RESEARCH REACTOR CENTER

April 15, 2016

SUBJECT: Written communication as specified by 10 CFR 50.4(b)(1) regarding responses to the
“University of Missouri at Columbia – Clarifications Needed to Nuclear Regulatory
Commission Staff Request for Additional Information Regarding the Renewal of
Facility Operating License No. R-103 for the University of Missouri at Columbia
Research Reactor (TAC No. ME1580),” dated March 23, 2016

Figure 1

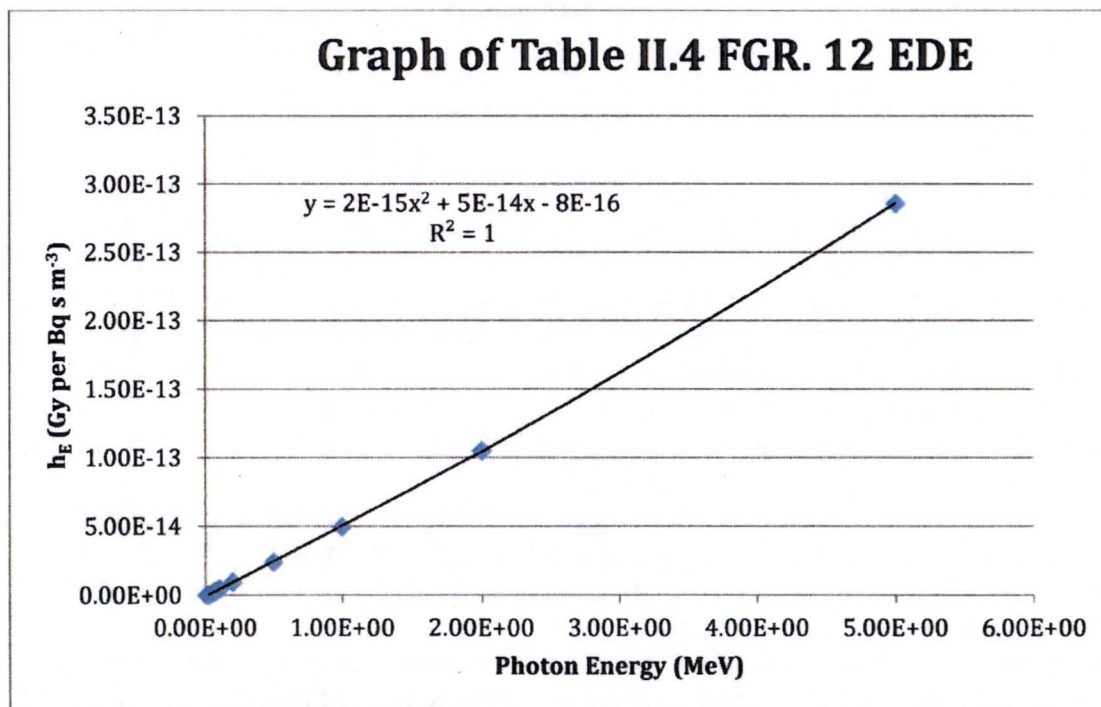
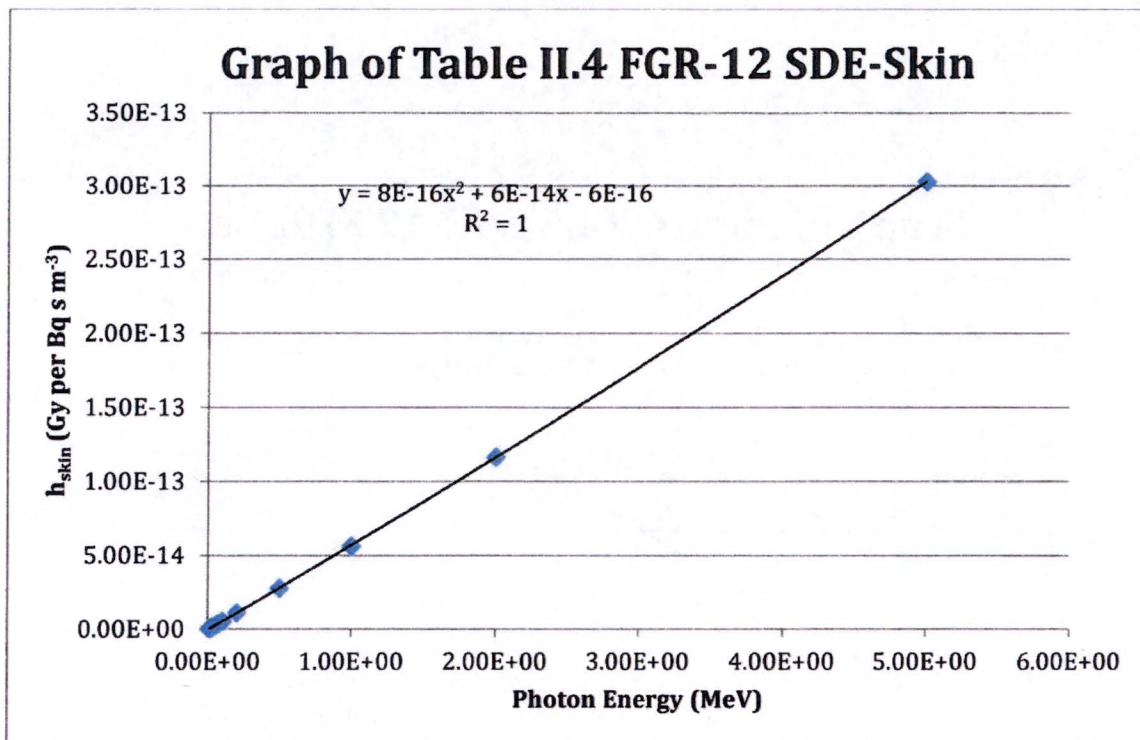
- *Correct Kr-90 dose by eliminating the negative dose contribution from the curve fit [page 20].*

The negative dose contribution from the curve fit has been eliminated; therefore, the new Kr-90 Derived Air Concentration value is 2.8×10^{-06} $\mu\text{Ci/ml}$ (see Attachment 4). This value now reflects that the whole body is the limiting organ and not the skin as in the previous analysis.

A direct repetition of the methodology of using interpolation of the data presented in Table II.4 of FGR-12 was used to calculate photon dose coefficients for each of the nuclides in question. The skin dose and effective dose equivalent data from Table II.4 FGR-12 were plotted in excel and assigned a best fit line used for the interpolation (See Figure 1 and 2).
